Bid Bulletin #02

PROJECT: Weeping Water Public Schools
Additions & Renovations
Weeping Water, NE

RE: Addendum No. 1 to the Bidding Documents for:
Weeping Water Public Schools
Additions & Renovation
204 West O Street
Weeping Water, Nebraska 68463
Schemmer Project No. 06368.001

This addendum consists of nine (9) pages of written addendum items and twenty-one (21) pages of supplemental drawings.

SHEET NO: SDE-4

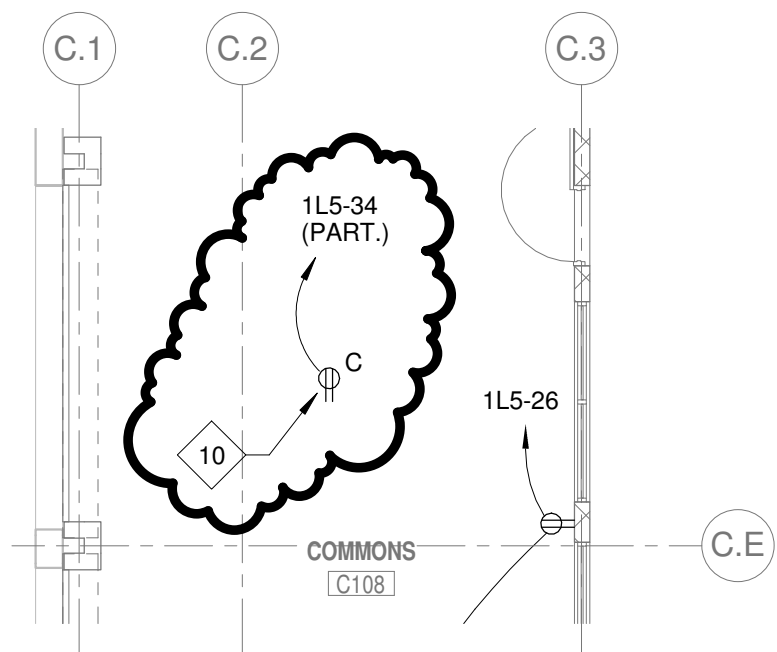
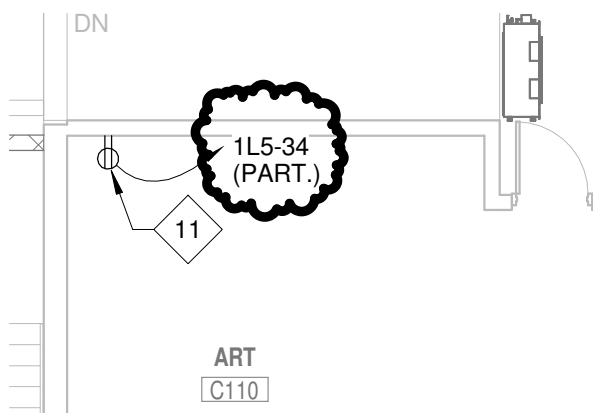
- 1) See attached SDE-4 for electrical revisions.
- 2) See attached SDE-5 for electrical revisions.
- 3) See attached SDE-11 for electrical revisions.

10. PROVIDE QUAD RECEPTACLE IN CEILING MOUNTED ENCLOSURE.

SHEET NO: SDE-6

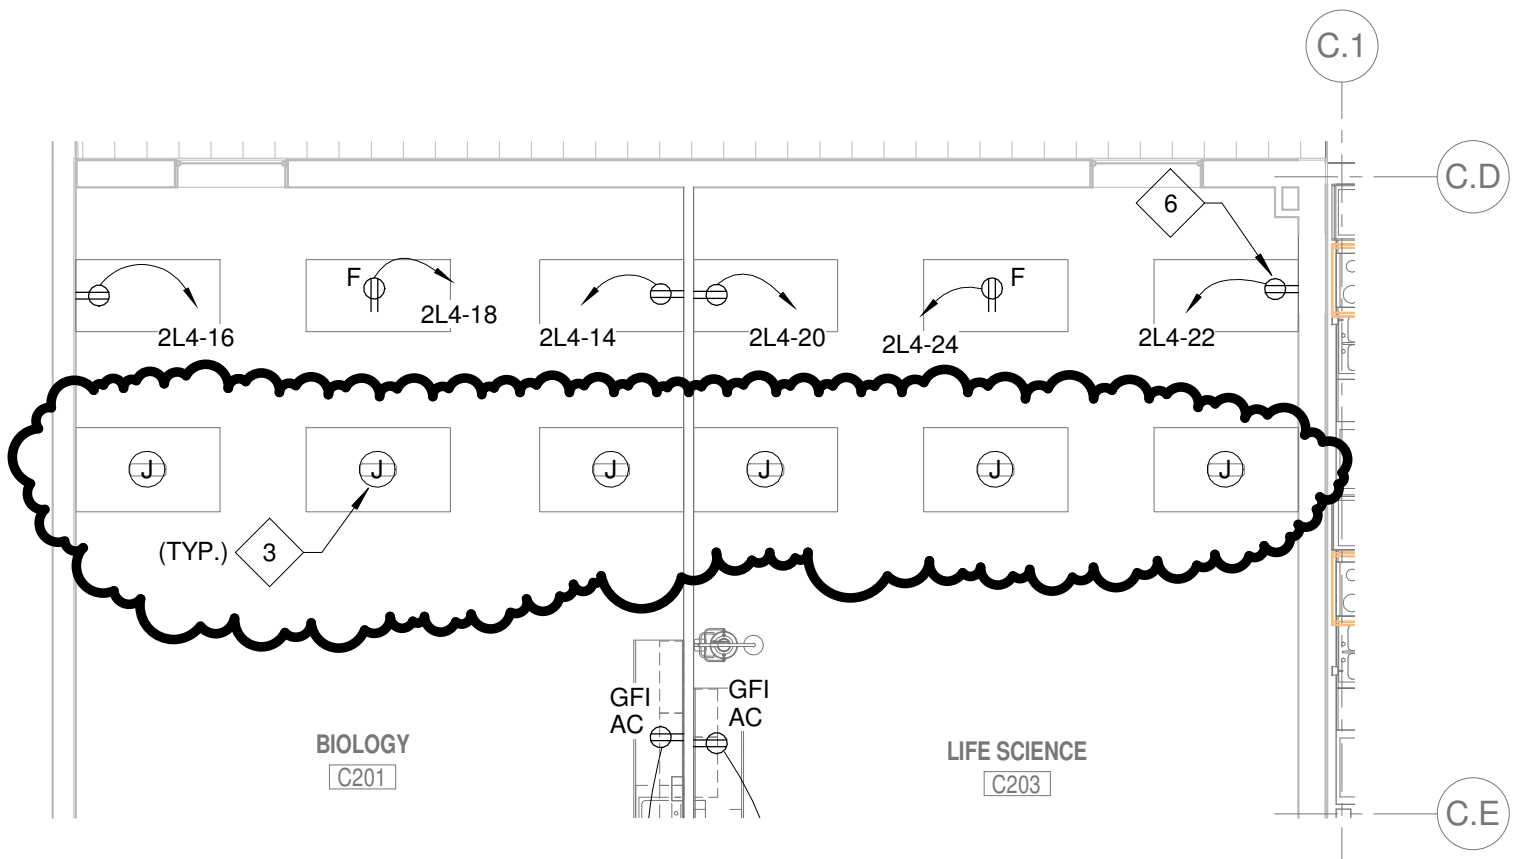
- 1) See attached SDE-6 for electrical revisions.

3. POWER FOR TABLE OUTLETS. PROVIDE POWER THROUGH FLOOR OR WALL, AS APPROPRIATE.

SHEET NO: SDE-7

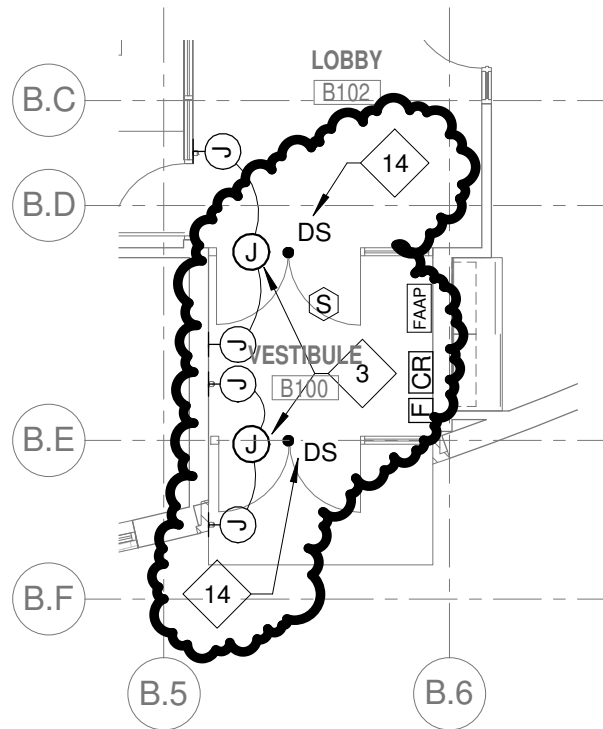
- 1) See attached SDE-7 for electrical revisions.

14. PROVIDE SECURITY ROUGH INS PER DETAIL 6, SHEET E4-01.

SHEET NO: SDE-8

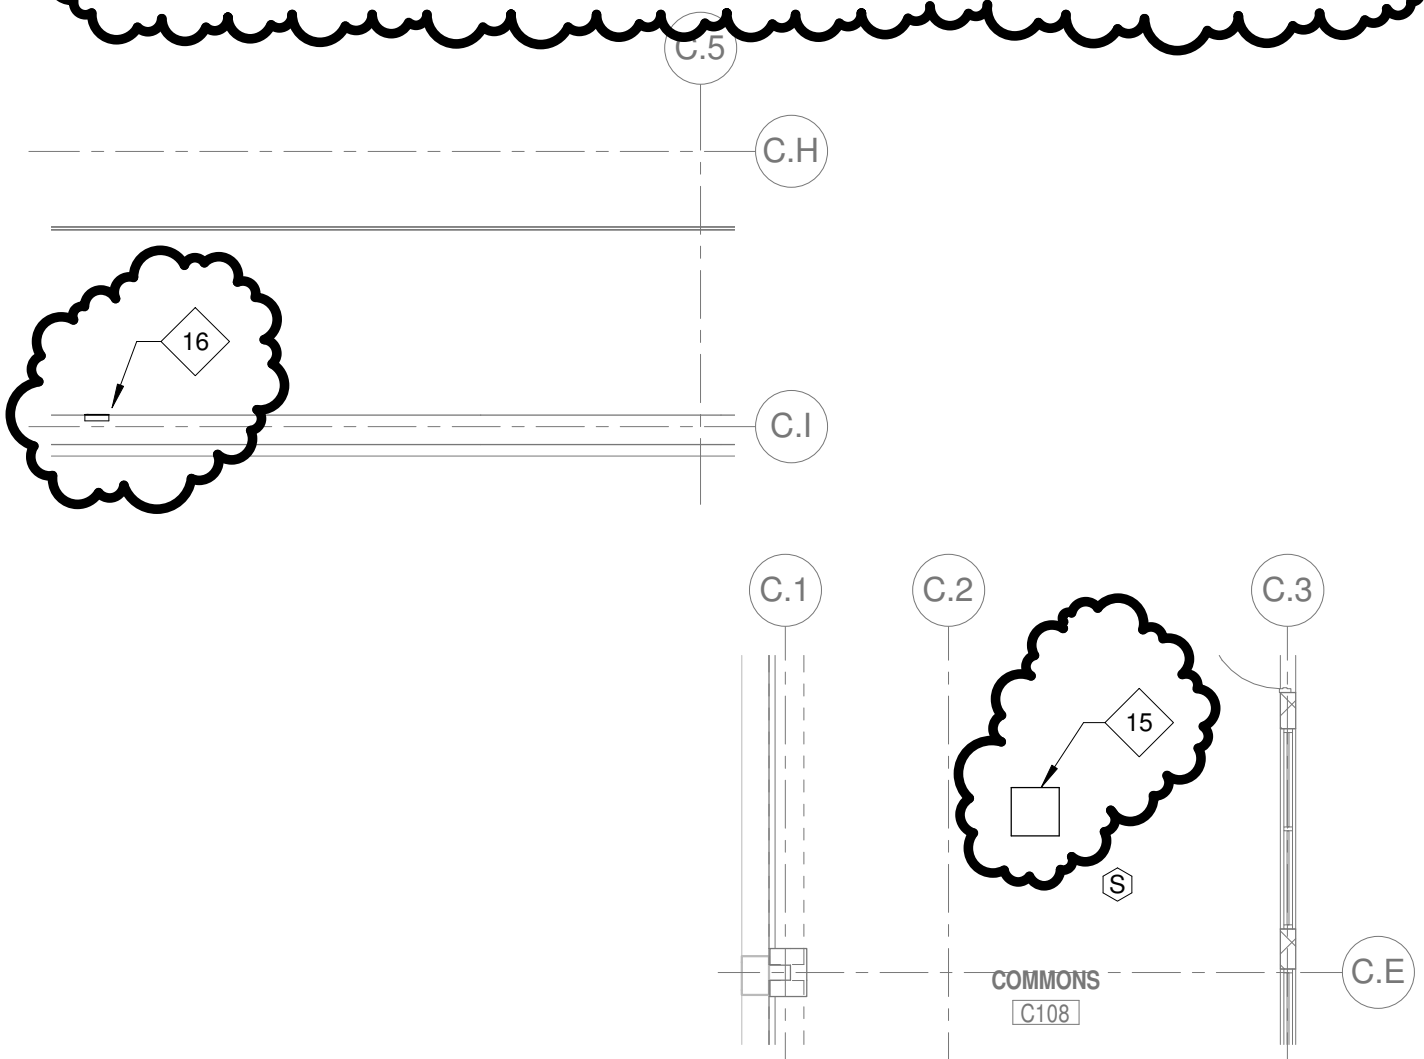
- 1) See attached SDE-8 for electrical revisions.
- 2) See attached SDE-9 for electrical revisions.
- 3) See attached SDE-11 for electrical revisions.

15. PROVIDE A WIRELESS ACCESS POINT (HP MODEL MSM460 OR EQUAL) WITH 1 PORT POWER INJECTOR (HP MODEL J9047B OR EQUAL). PROVIDE 1 CAT 6 ETHERNET CABLE TO COMMUNICATIONS EQUIPMENT IN CEILING MOUNTED IDF. COORDINATE EXACT LOCATION WITH OWNER PRIOR TO ROUGH IN. INSTALL CEILING MOUNT HUBBELL RE-BOX ENCLOSURE FOR WIRELESS ACCESS POINTS (MODEL NO. WBC12) OR EQUAL.

16. PROVIDE A WIRELESS ACCESS POINT (HP MODEL MSM460 OR EQUAL) WITH 1 PORT POWER INJECTOR (HP MODEL J9047B OR EQUAL). PROVIDE 1 CAT 6 ETHERNET CABLE TO COMMUNICATIONS EQUIPMENT IN CEILING MOUNTED IDF. COORDINATE EXACT LOCATION WITH OWNER PRIOR TO ROUGH IN. INSTALL HUBBELL RE-BOX FOR WIRELESS ACCESS POINTS (MODEL NO. WBW10W) OR EQUAL. MOUNT 72" ABOVE TRACK.

SHEET NO: SDE-10

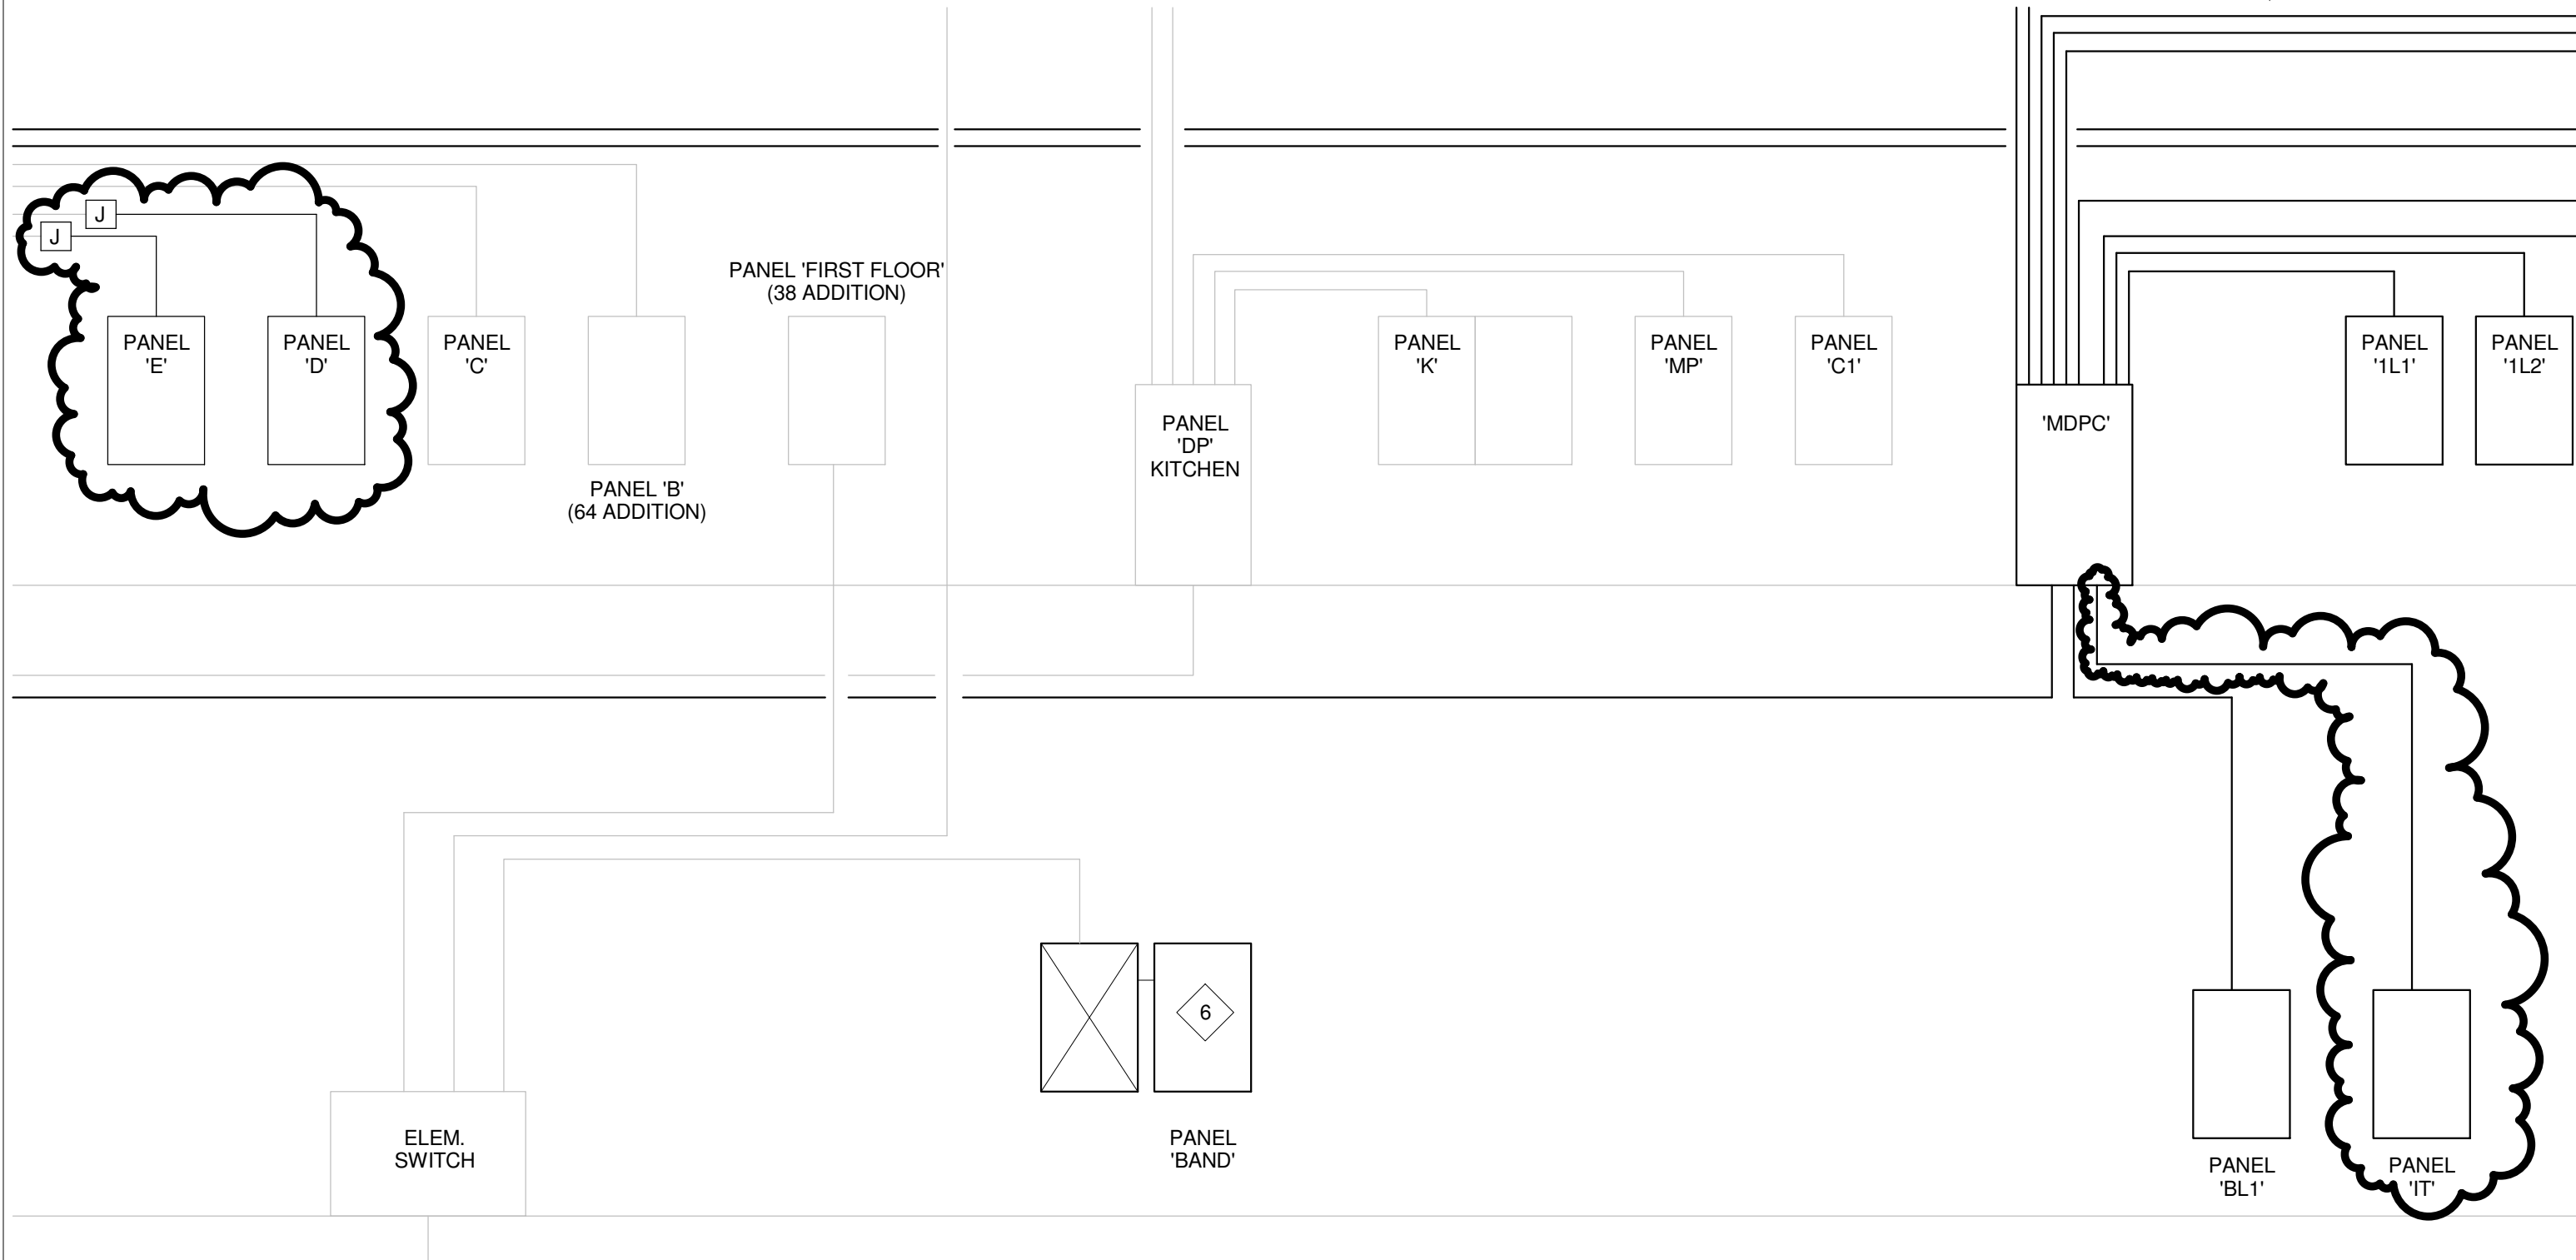
- 1) See attached SDE-10 for electrical revisions.
